DEVELOPMENT REVIEW BOARD
SUPPLEMENTAL SUBMITTAL

PROJECT NO. PR-2021-006258

Application No. SD-2022-00005

Subject-Brunacini Warehouse- PR-2021-006258

REVISIONS
 DATE FEBRUARY 16, 2022
 SCALE
 1/16"=1'-0"
 OR AS NOTED
 DRAWING NAME
BUILDING ELEVATIONS
 SHEET NUMBER
SDP-2

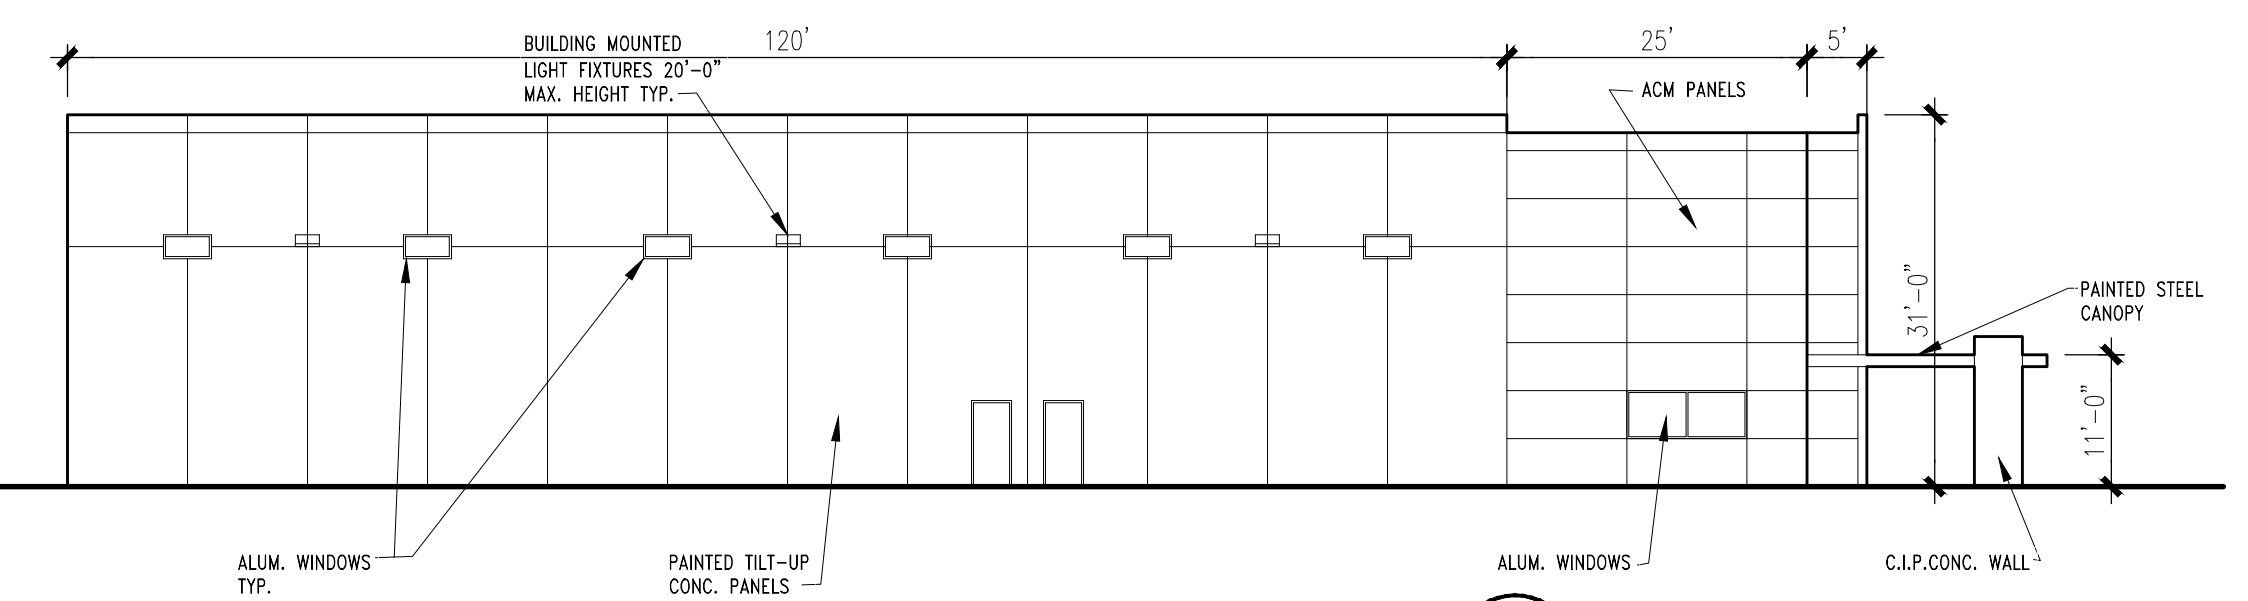
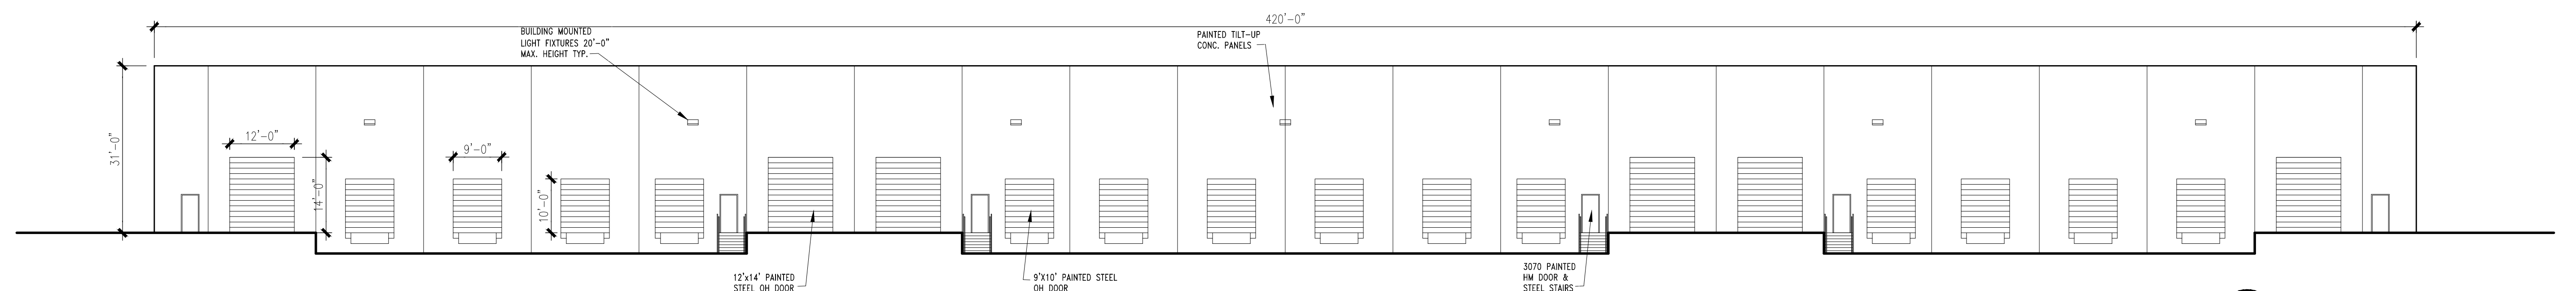
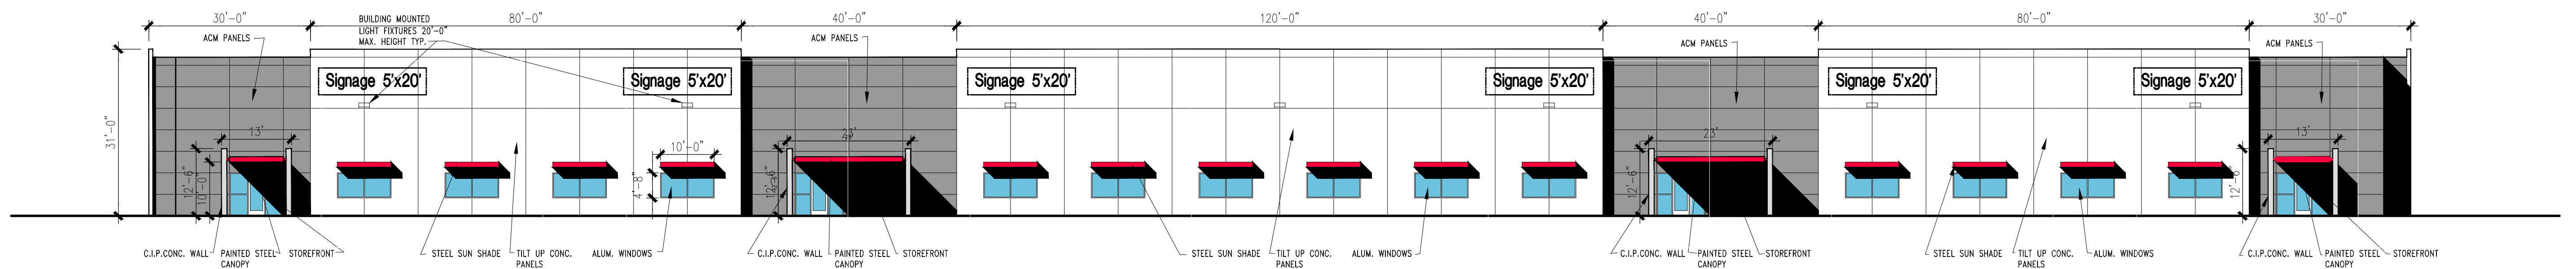
This memo is in response to your 5th comment of your first review of the above project.

"The building facades must meet 5-11(E) of the IDO.

5-11(E) (2) (a)

1. Canopies and entries provide human scale
2. The two features provided are c. primary pedestrian entrances and d. shade elements over windows.
3. The additional feature are the wall plane projections.

Please refer to the submitted building elevations and the architectural rendering for visual reference. Let us know if you need any further clarification.
